CHESHIRE PUBLIC LIBRARY PARKING LOT IMPROVEMENTS

RFP #2223-31

[ADDENDUM NO. 1](#)

April 4, 2023

1. Corrected Extruded Concrete Curb detail.

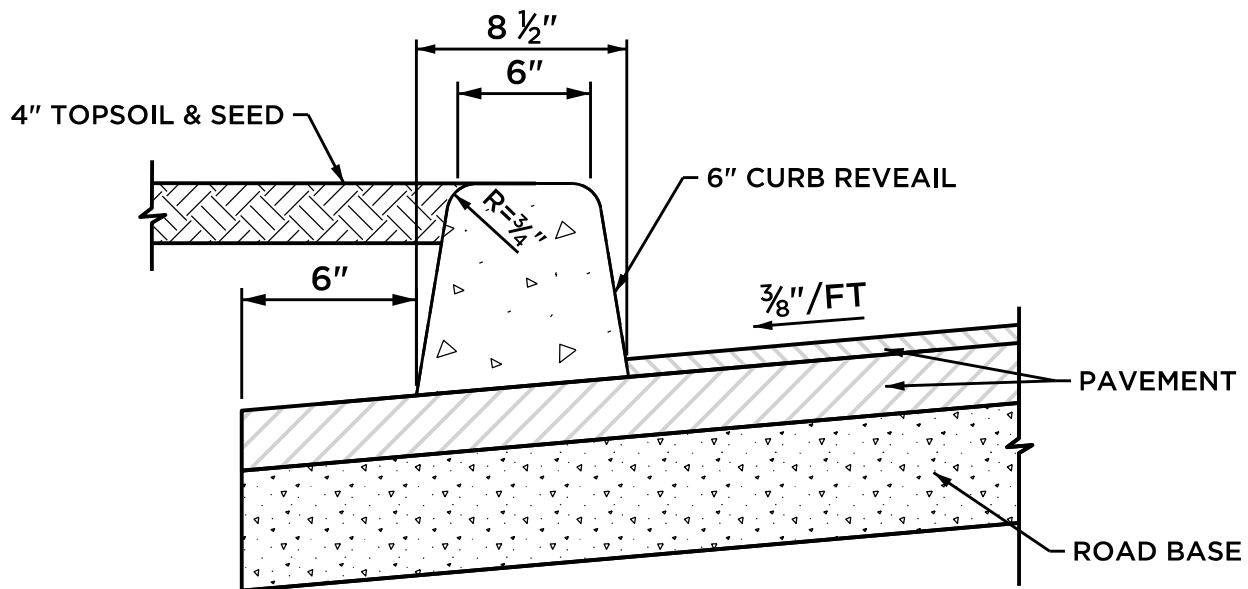
Question 1: Drawing shows extruded concrete curb on the reclaimed base, is that what you want?

Question 2: Do you want the extruded concrete curb on the binder?

Question 3: Do you want the extruded concrete curb on the top course?

Question 10: The Extruded Curbing on the plan details says a 9" curb on gravel base with a 6" reveal, but on the description page line R says 6" extruded curb?

Response 1: **The extruded concrete curb is to be placed on top of the pavement binder course. Corrected detail is attached.**

Response 2: **The extruded concrete curb is to be placed on top of the pavement binder course. Corrected detail is attached.**

Response 3: **The extruded concrete curb is to be placed on top of the pavement binder course. Corrected detail is attached.**

Response 10: The extruded concrete curb is to be placed on top of the pavement binder course with a 6" reveal. Corrected detail is attached.
